To: Mark Hutchinson, SLO County, LOWWP Staff

From: Alon Perlman, Los Osos. CA

Date: January 29, 2009

Re: LOWWP Draft EIR Comments submitted herein

**Source Table 5.11-2: Agricultural Resources Proposed Mitigation Measures”**

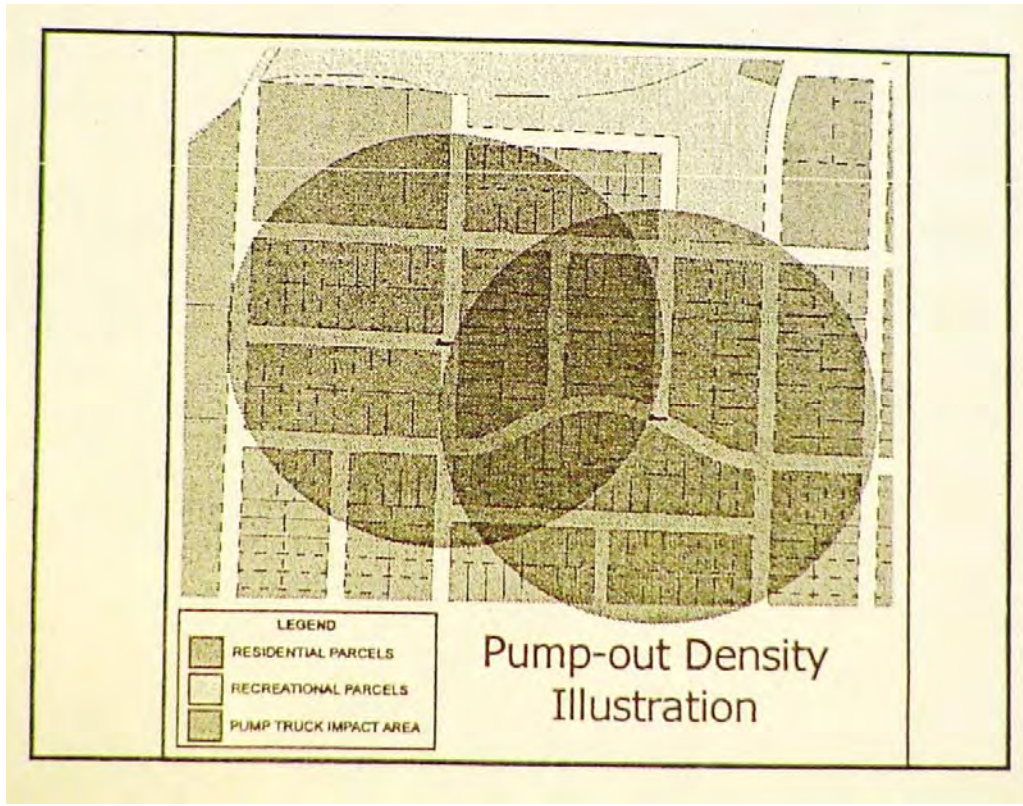
*“The proposed Tonini sprayfields would include a combination of evapotranspiration (ET) and percolation and ET only. The actual split between land that is suitable for ET and percolation and land that is suitable only for ET will be determined as part of the design process. Other site conditions such as providing buffers along coastal streams will be accommodated in the final design”*

*There would be indirect impacts within the Tonini parcel due to **accidental spray dispersing beyond the direct affected areas** (refer to Mitigation Measure 5.11-B1 below) into grazing or stream buffer areas.*

## **Greenhouse Gas Emissions**

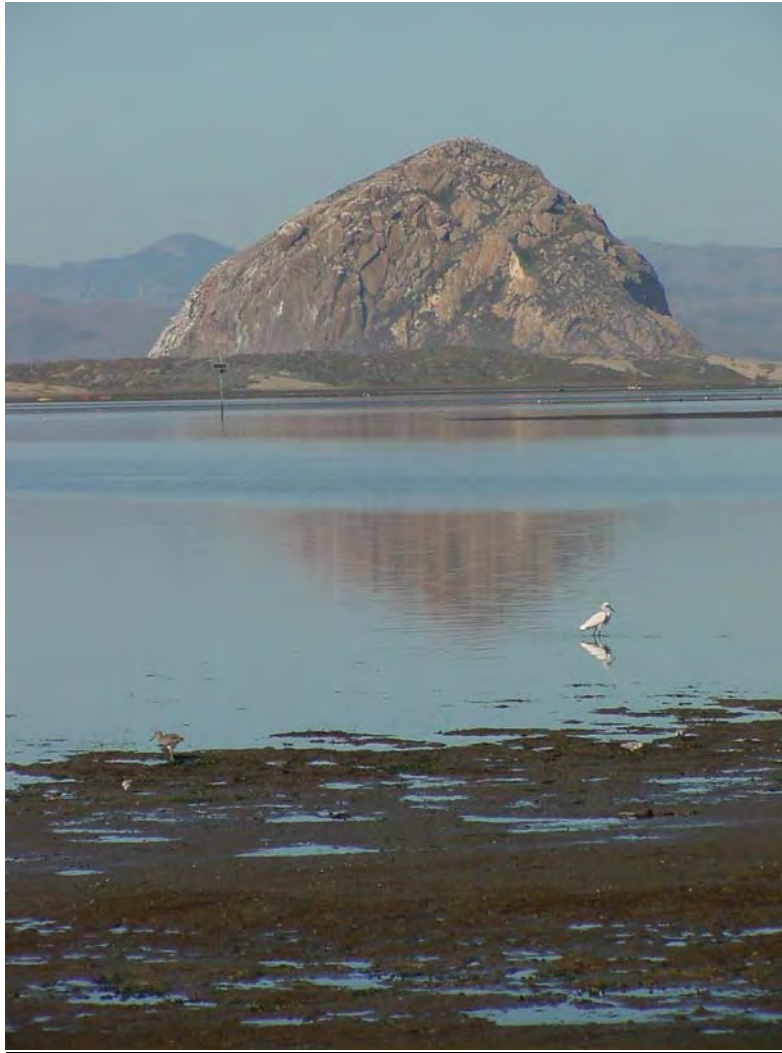
Effectively a wash in the opinion of this reviewer. Due to operating under the structure of "Meeting Thresholds", all projects are considered the same. This makes it harder to review "co-equal analysis" in order to identify or quantify the best project. But that is not the regulatory primary concern. The regulatory body is interested in mitigating and protecting for maximum health and environmental protection.

In order to grow as a grass the plant sequesters carbon dioxide (which is good, trapping a green house gas). After transportation to the landfill, the grass decomposes re releasing some of the carbon dioxide (which is ok) and methane (which can be collected as fuel which is good, or allowed to escape into the atmosphere which is bad) unrecovered methane and other released decomposition gasses can be worse green house gasses. Is potential recombination, release of methane an affect? Is it recognized in the DEIR? Mitigated?
